AMENDMENT 001

Title Integration of a CO2 heat pump, CanmetENERGY, Varennes	
Solicitation No. NRCan-5000041458	Date October 15, 2018
Client Reference No. 149342	
Solicitation Closes at 02:00 PM (Eastern Daylight Savings Time (EDT)) on October 24, 2018	
Address Enquiries to: france.bolduc@canada.ca	
No de telephone 418 648-5043	No. de Fax 418 648-2529
Destination – of Goods, Services and Construction: Natural Resources Canada CanmetENERGY 1615 Lionel-Boulet Varennes, QC J3X 1S6	
Security There is no security requirements associated with this requirement.

ADDENDA /ADDENDUM N° M-1

<p>Projet/Project: Projet Ipac - Pompe à chaleur Géothermique au CO2/ Ipac project - CO2 geothermal heat pump</p>	<p>Discipline: Mécanique/Mechanical</p>	
<p>Émis à/ Issued to: Antoine Langlois, Ressources Naturelles Canada, Gouvernement du Canada/ Natural Resources Canada, Government of Canada</p>	<p>Copie à/ Copy to: Soumissionnaires/ Tenderers</p>	
<p>Émis par: Éric Dupuis, tech. Claude Beaudry, ing.</p>  <p>Signature numérique de Claude Beaudry DN : cn=Claude Beaudry, o=Le Groupe Conseil Berman Inc., ou=Ingenieur 33954, email=cbeaudry@gr-berman.ca, c=CA Date : 2018.10.15 08:21:01 -0400'</p>	<p>Date: 15

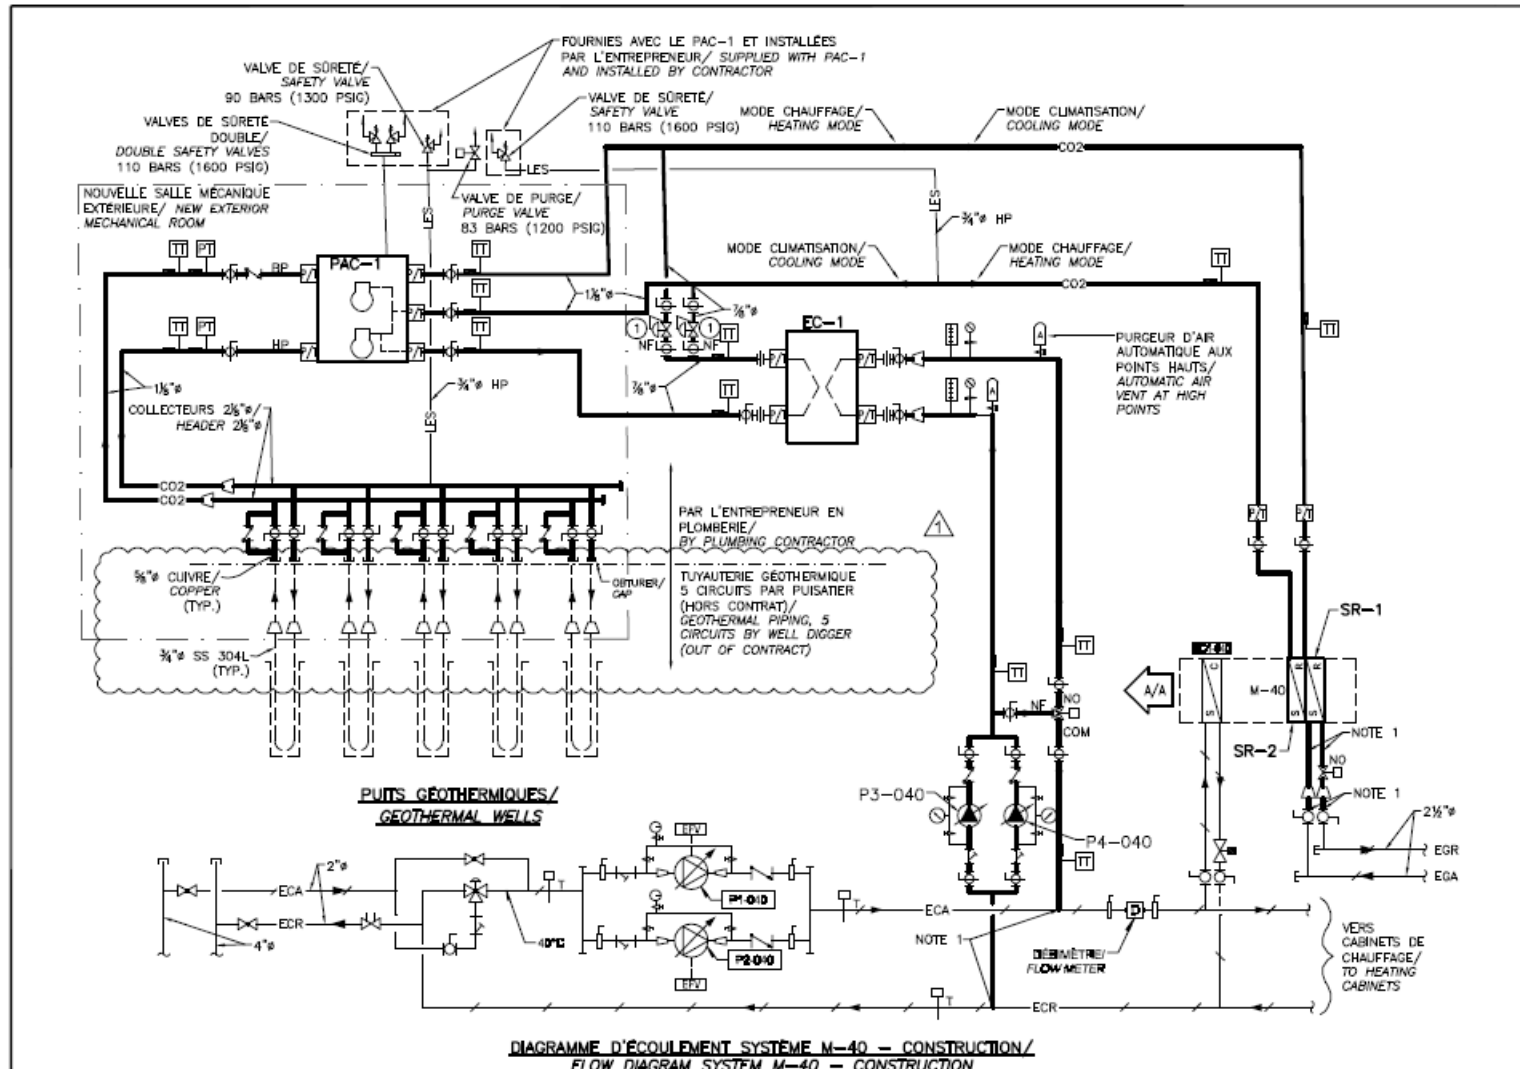
- .1 Les raccordements entre les puits géothermiques et les robinets d'isolement des collecteurs CO2 ne font pas partie de l'étendue des travaux. Installer des capuchons sur ces robinets, ainsi que sur les clapets de retenues. Voir dessin SKMAD1-1, extrait du dessin H03-HG-DET./ Connections between the geothermal wells and the isolating valves of the CO2 headers are not part of the scope of work. Provide caps for these valves and the check valves. See drawing SKMAD1-1, extract from drawing H03-HG-DET.
